Access Compliance Report

Public Rights-of-Way (Curb Ramps)

Intersection ID: 19036	Main Street: RANDOLPH_RD	Cross Street: RANDSTONE_CT	Location: S
ADA ID: 319724E2FF64	Ramp Type: Perp	Initial Pass/Fail: Fail	Overall Compliance: No
Severity Score: 12.5			
Codes/Mitigation Info/Possible Solution		Field Measurements/Component Compliance

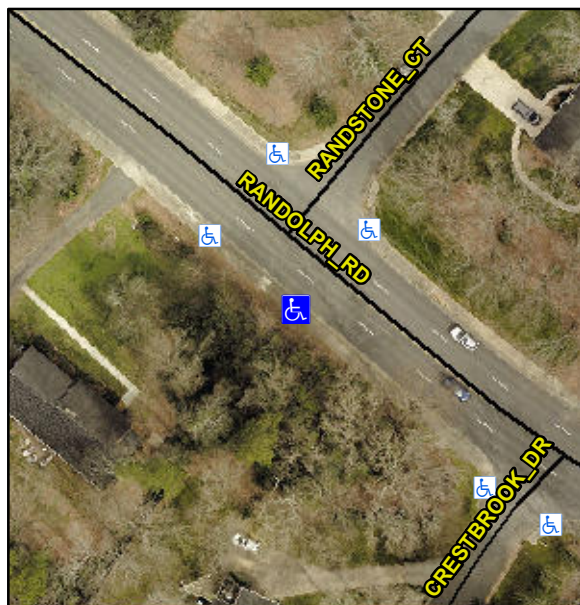
Not Found, R304.5.3

Compliance	Description	Data	Compliance	Description	Data
N/A	Ramp Length (in)	71.0	Yes	Ramp Slope (%)	6.0
Yes	Ramp Width (in)	48.0	No	Ramp XSlope (%)	5.1
N/A	Flare Type LT	N/A	N/A	Flare Type RT	N/A
N/A	Flare Slope LT (%)	N/A	N/A	Flare Slope RT (%)	N/A
N/A	Flare Traversable LT?	N/A	N/A	Flare Traversable RT?	N/A
N/A	Landing Length (in)	N/A	N/A	DWS Provided?	N/A
N/A	Landing Width (in)	N/A	N/A	DWS Contrast?	N/A
N/A	Landing Slope (%)	N/A	N/A	DWS Length (in)	N/A
N/A	Landing X Slope (%)	N/A	N/A	DWS Full Width?	N/A
N/A	Landing Curb? (Y/N)	N/A	N/A	DWS Offset (in)	N/A
N/A	Shared Landing?	N/A			
N/A	Gutter Ponding?	N/A	N/A	Gutter Slope (%)	N/A
N/A	Gutter Lip Ht (in)	N/A	N/A	Gutter X Slope (%)	N/A
N/A	Painted X Walk1?	No	N/A	Painted X Walk2?	N/A
	X Walk 1 Direction	To NE		X Walk 2 Direction	N/A
N/A	X Walk 1 Width (in)	N/A	N/A	X Walk 2 Width (in)	N/A
	X Walk 1 Slope (%)	2.4		X Walk 2 Slope (%)	N/A
	X Walk 1 X Slope (%)	3.6		X Walk 2 X Slope (%)	N/A

Remove & Replace Entire Ramp.
